INDESIT company

BAAN14

F043661

51520g0 Exploded views

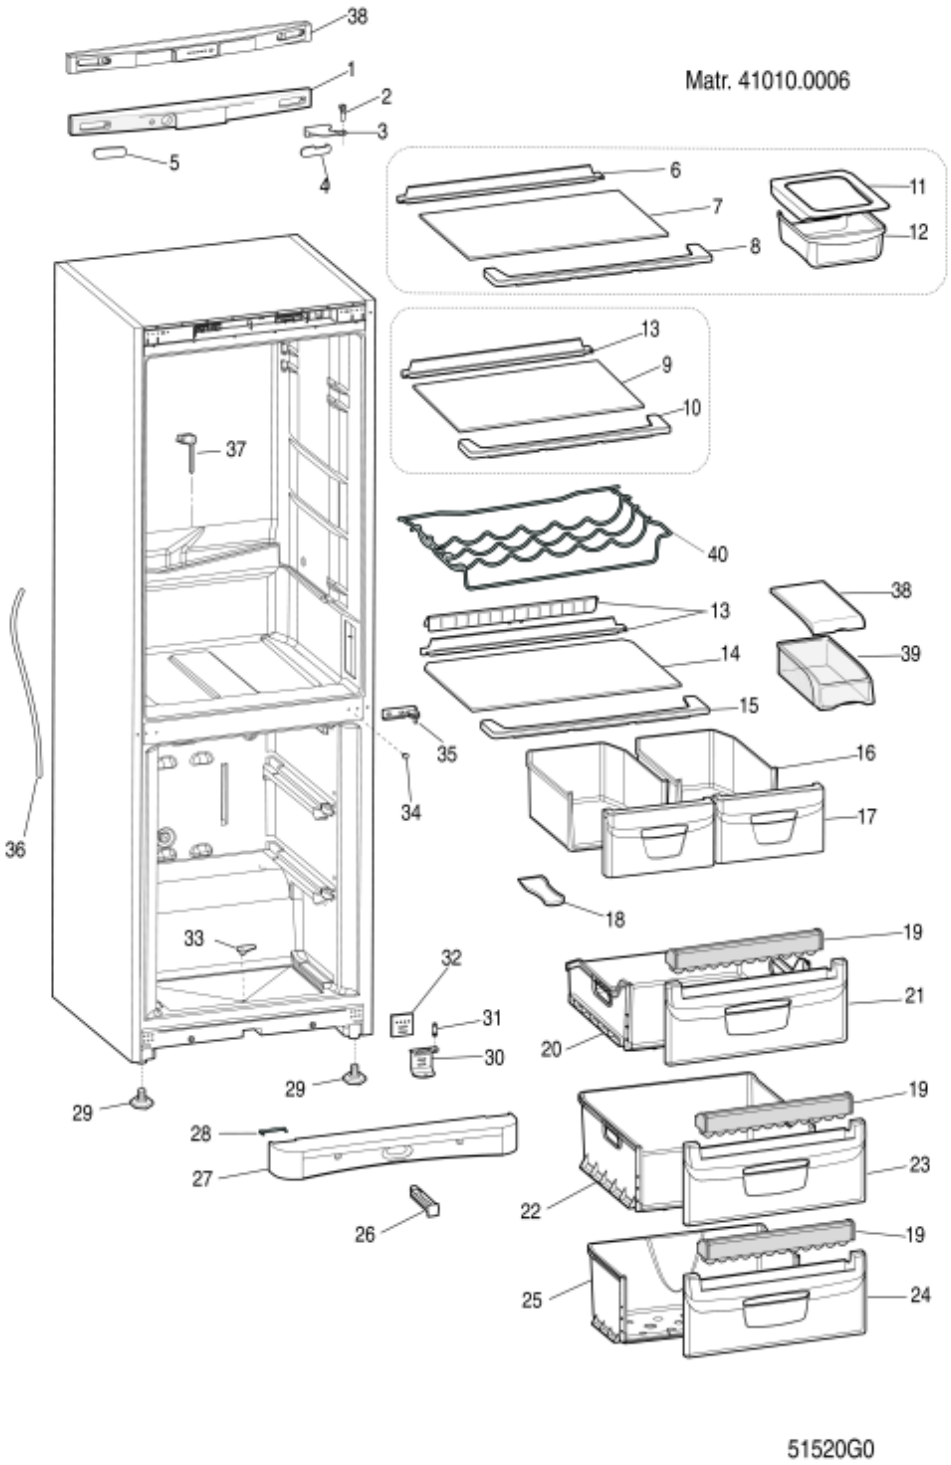
n2511b02: ELIMINATION COVER FOR UPPER DOOR SHELF-INTERNAL ACCESSORIES RESTYLING

Cover for upper door shelf has been eliminated. The upper door shelf has been standardized with the middle one. Subsequently has been standardized with transparent internal accessories instead of those in light blue colour once stock has depleted.

n3012e00: KICKPLATE+DRAIN ELIMINATION

Kickplate+drain has been repalced by the version without drain hole.

51521F0

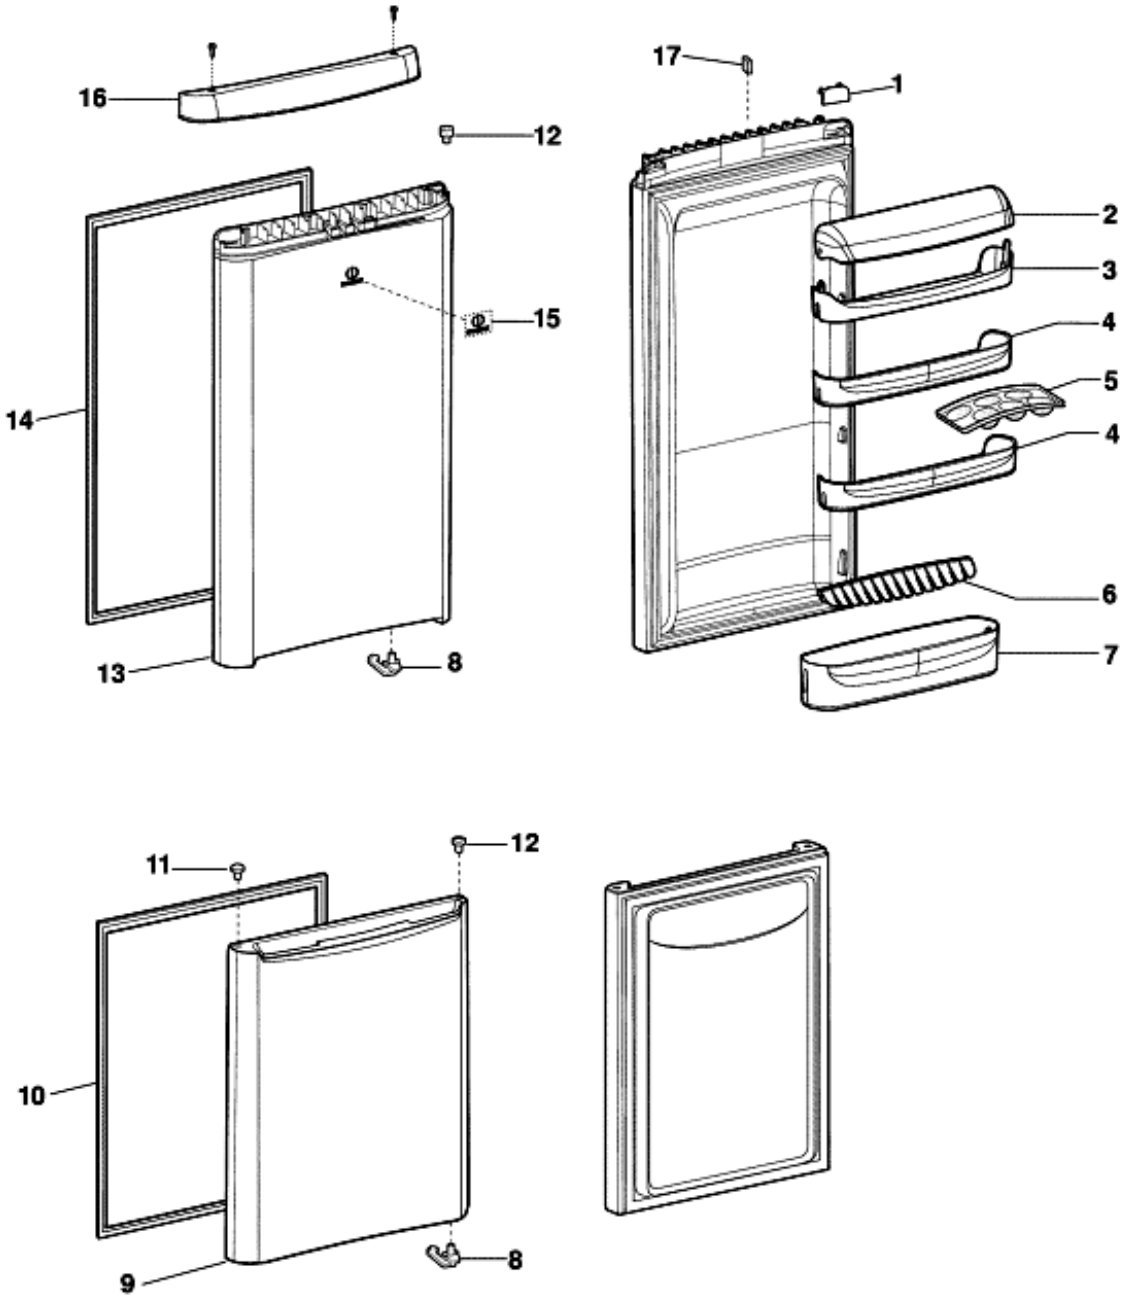
n3012b00: EGGS HOLDER ELIMINATED
